Access Compliance Report

Public Rights-of-Way

(Curb Ramps)

Intersection ID: 43644	Main Street: CEDAR_CROSSINGS_DR	Cross Street: KENDRICK_CROSS_RD	Location: SE
ADA ID: 3C2E246418E4	Ramp Type: PerpDiag	Initial Pass/Fail: Fail	Overall Compliance: No
Codes/Mitigation Info/Possible Solution		Field Measurements/Component Compliance	
Severity Score: 33.75

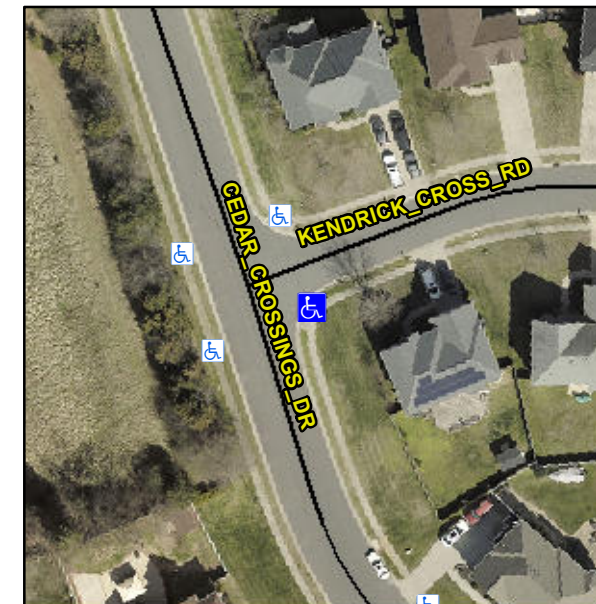
R304.5.1, R304.2.2

Compliance	Description	Data	Compliance	Description	Data
N/A	Ramp Length (in)	44.0	No	Ramp Slope (%)	12.3
No	Ramp Width (in)	47.0	Yes	Ramp XSlope (%)	1.1
N/A	Flare Type LT	N/A	N/A	Flare Type RT	N/A
N/A	Flare Slope LT (%)	N/A	N/A	Flare Slope RT (%)	N/A
N/A	Flare Traversable LT?	N/A	N/A	Flare Traversable RT?	N/A
N/A	Landing Length (in)	N/A	N/A	DWS Provided?	N/A
N/A	Landing Width (in)	N/A	N/A	DWS Contrast?	N/A
N/A	Landing Slope (%)	N/A	N/A	DWS Length (in)	N/A
N/A	Landing X Slope (%)	N/A	N/A	DWS Full Width?	N/A
N/A	Landing Curb? (Y/N)	N/A	N/A	DWS Offset (in)	N/A
N/A	Shared Landing?	N/A			
N/A	Gutter Ponding?	N/A	N/A	Gutter Slope (%)	N/A
N/A	Gutter Lip Ht (in)	N/A	N/A	Gutter X Slope (%)	N/A
N/A	Painted X Walk1?	No	N/A	Painted X Walk2?	No
	X Walk 1 Direction	To N		X Walk 2 Direction	To W
N/A	X Walk 1 Width (in)	N/A	N/A	X Walk 2 Width (in)	N/A
	X Walk 1 Slope (%)	4.6		X Walk 2 Slope (%)	2.4
	X Walk 1 X Slope (%)	3.0		X Walk 2 X Slope (%)	3.4

Remove & Replace Curb Ramp With Two New Directional Ramps or Equivalent.
